**ADDENDUM No. 1**  
**FOR**  
**HURON PARK, JACK DARLING COMFORT STATIONS**  
**830 PAISLEY BOULEVARD WEST & 1180 LAKESHORE ROAD WEST**  
**&**  
**JACK DARLING EAST COMFORT STATION**  
**1180 LAKESHORE ROAD WEST**  
**PROCUREMENT NO. PRC005197**

**PROJECT No: 24-053 & 25-059**

**DATE: NOVEMBER 6, 2025**

Structural Addendum #1

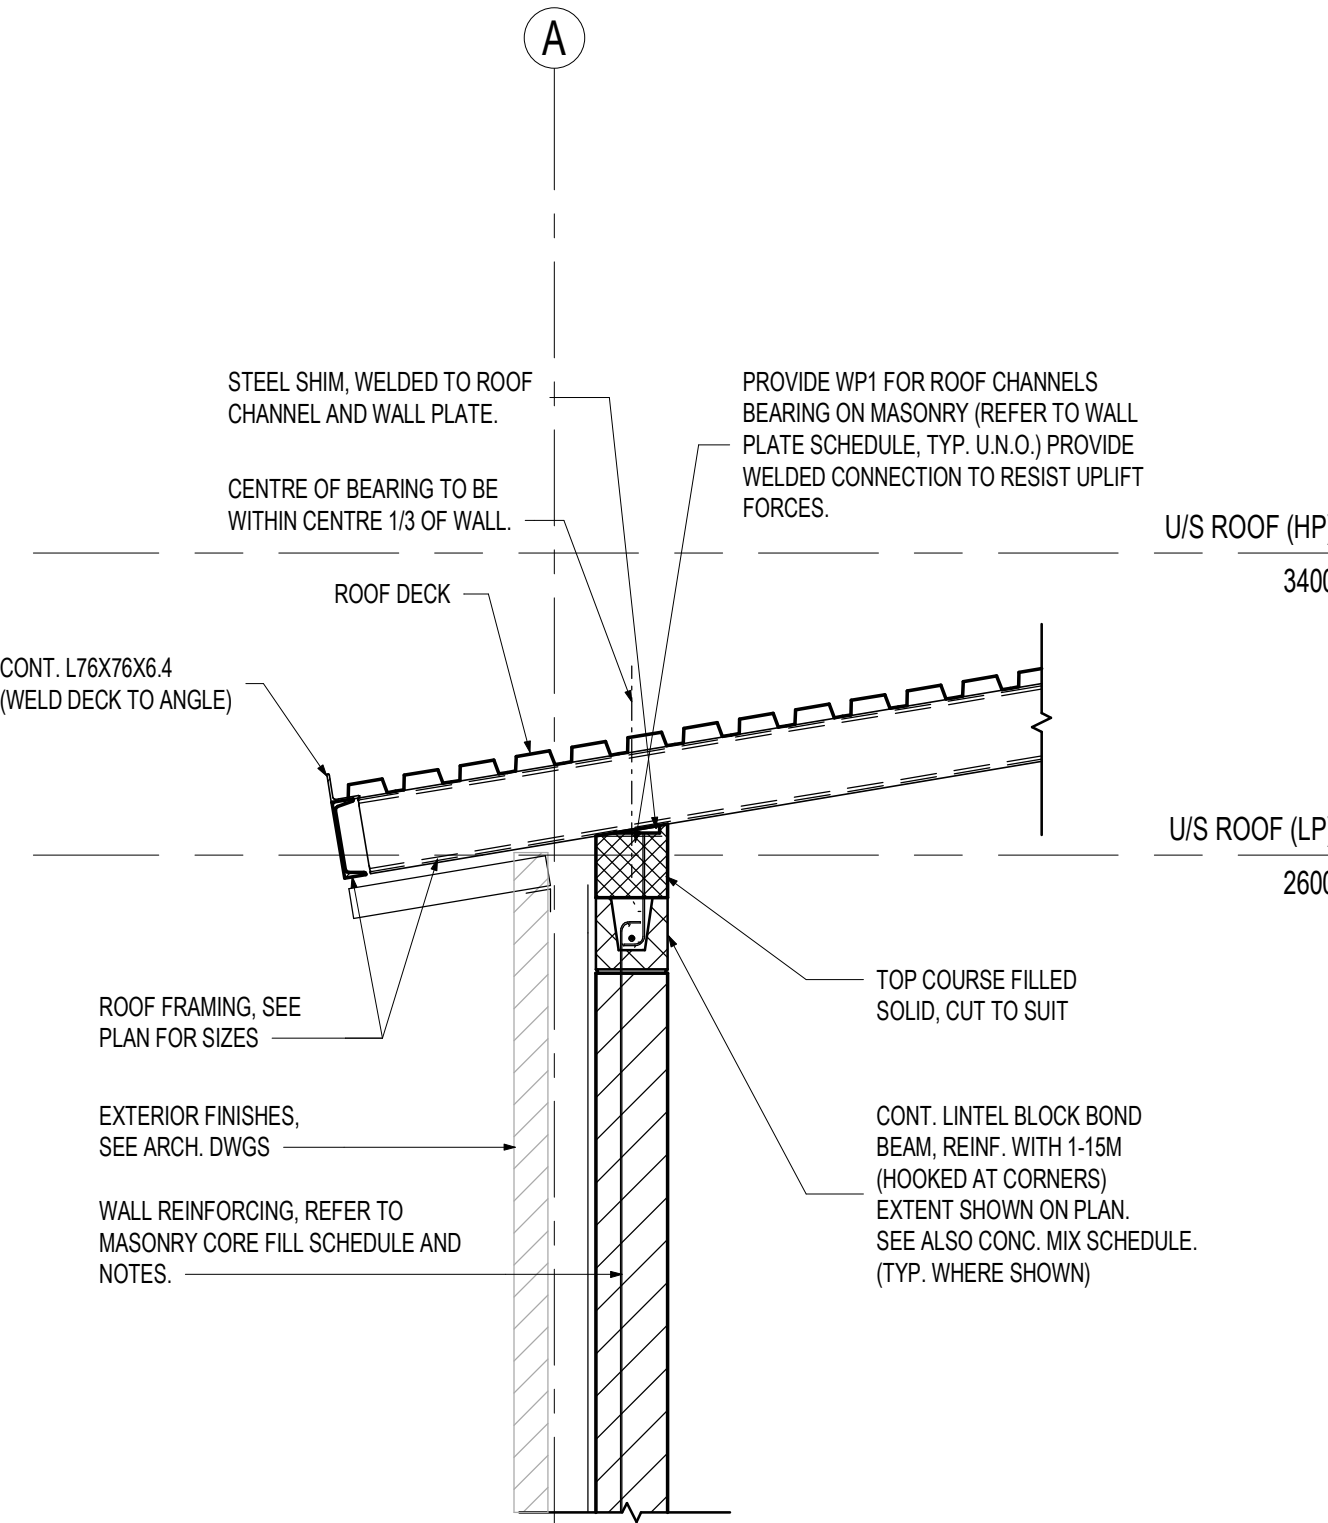
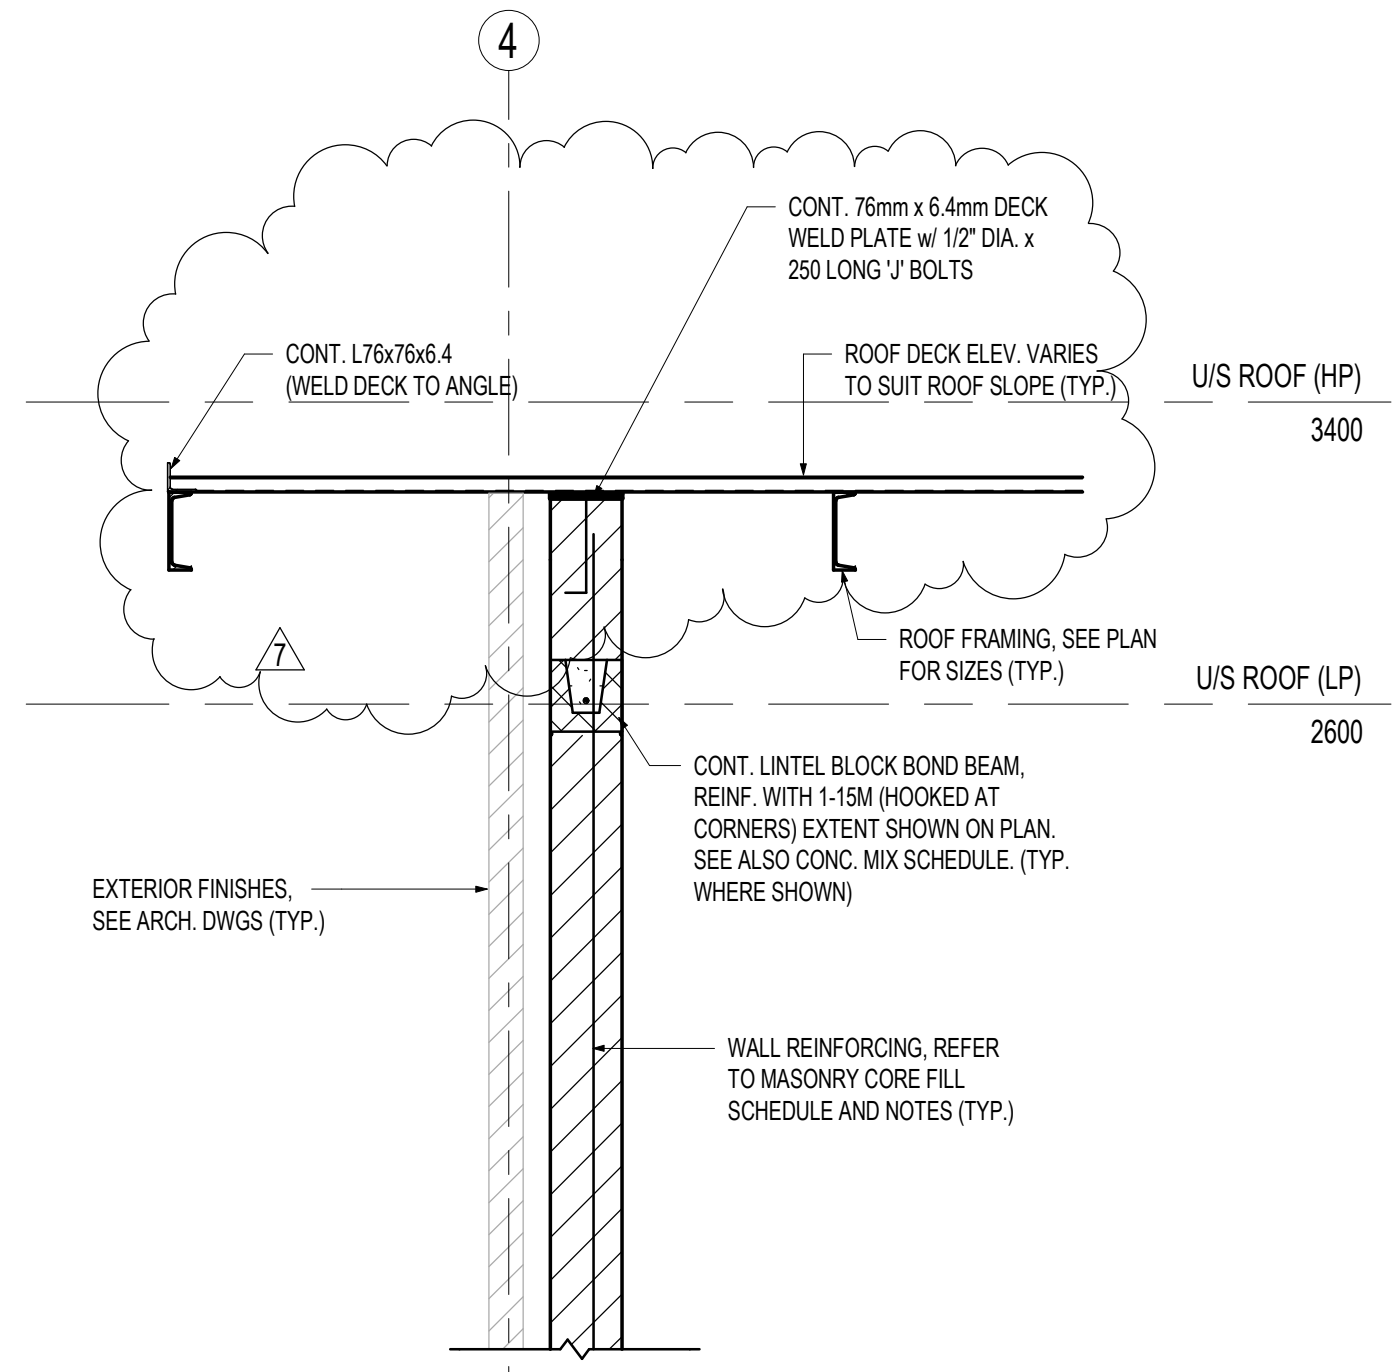
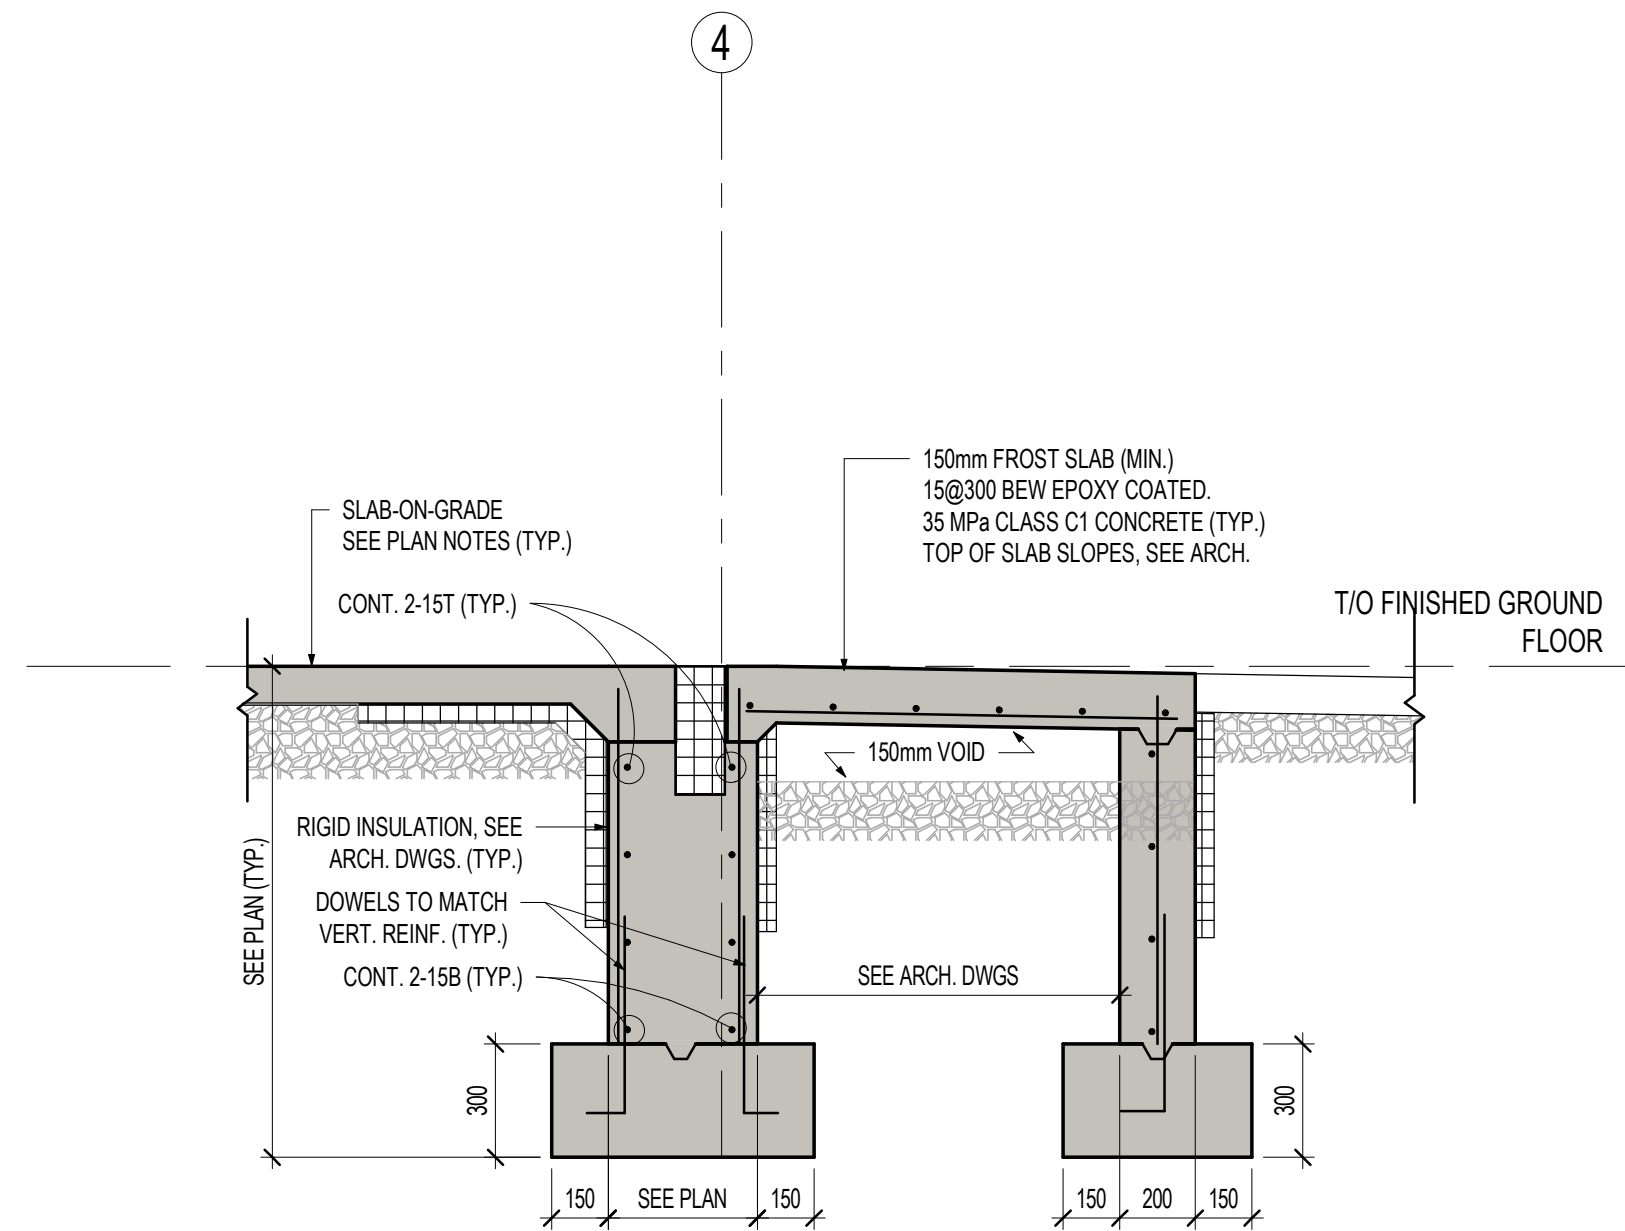
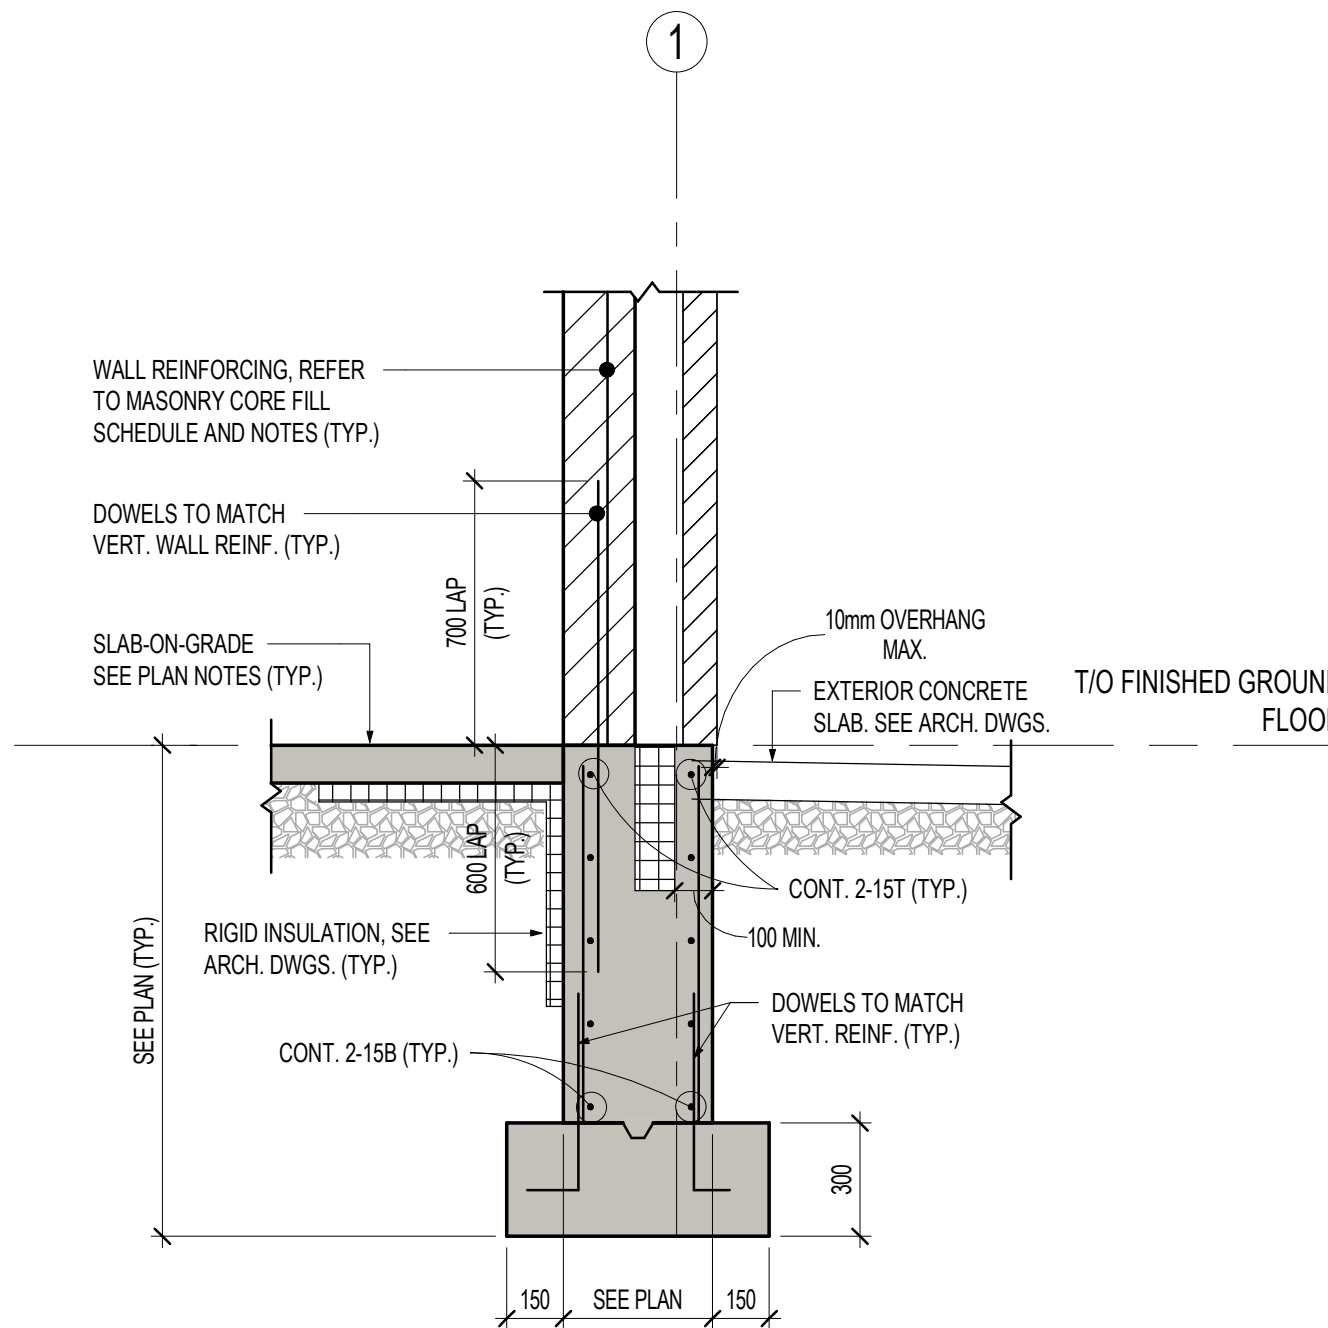
- .1 Mechanical lintel locations revised.
- .2 Masonry walls along grids 1 and 4 now extend and shall be connected to the roof deck.  
See section R3/S2-01

**3. Drawing E103 (Re Issued)**

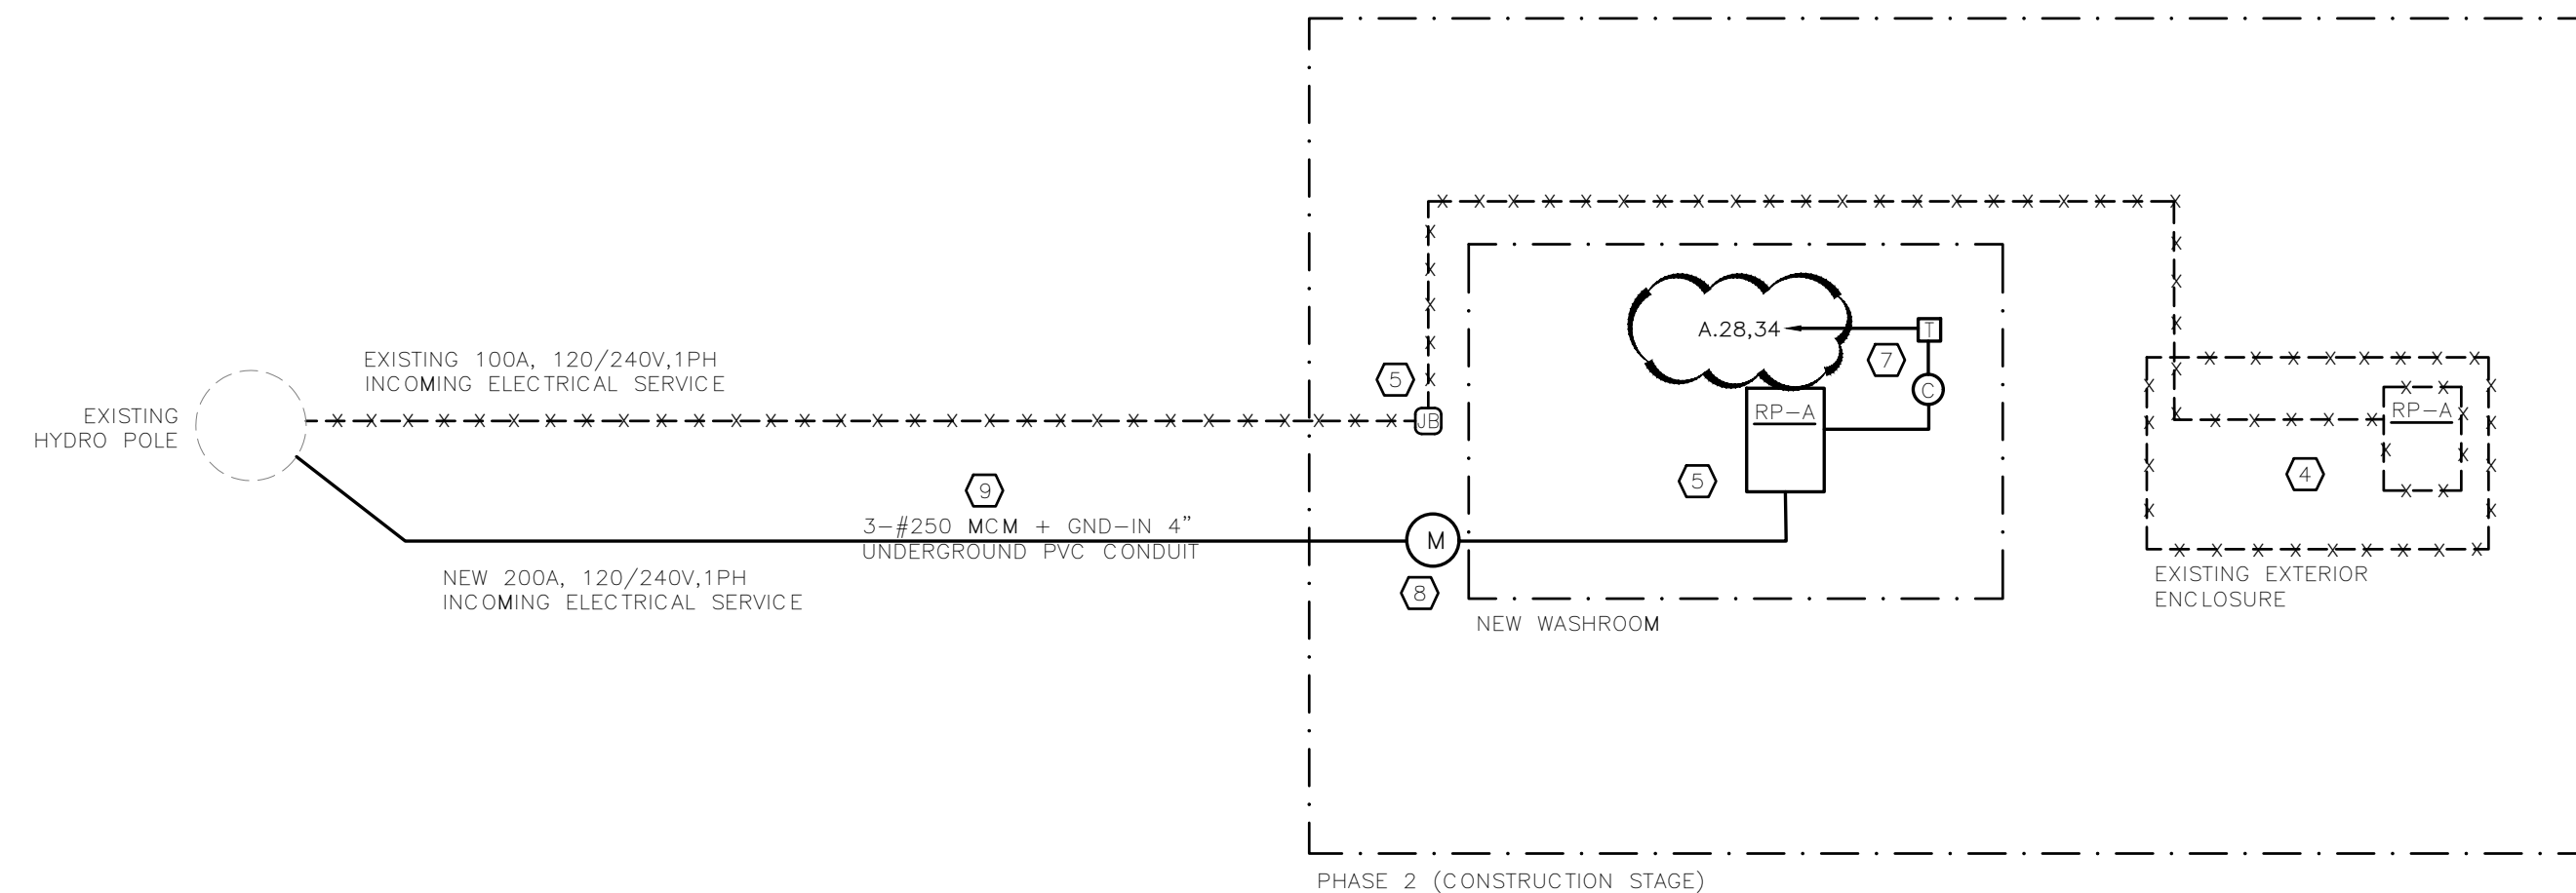
3.1. Revise the electrical panel as indicated.

3.2. Revise the exterior lighting circuiting to add an additional circuit as indicated.
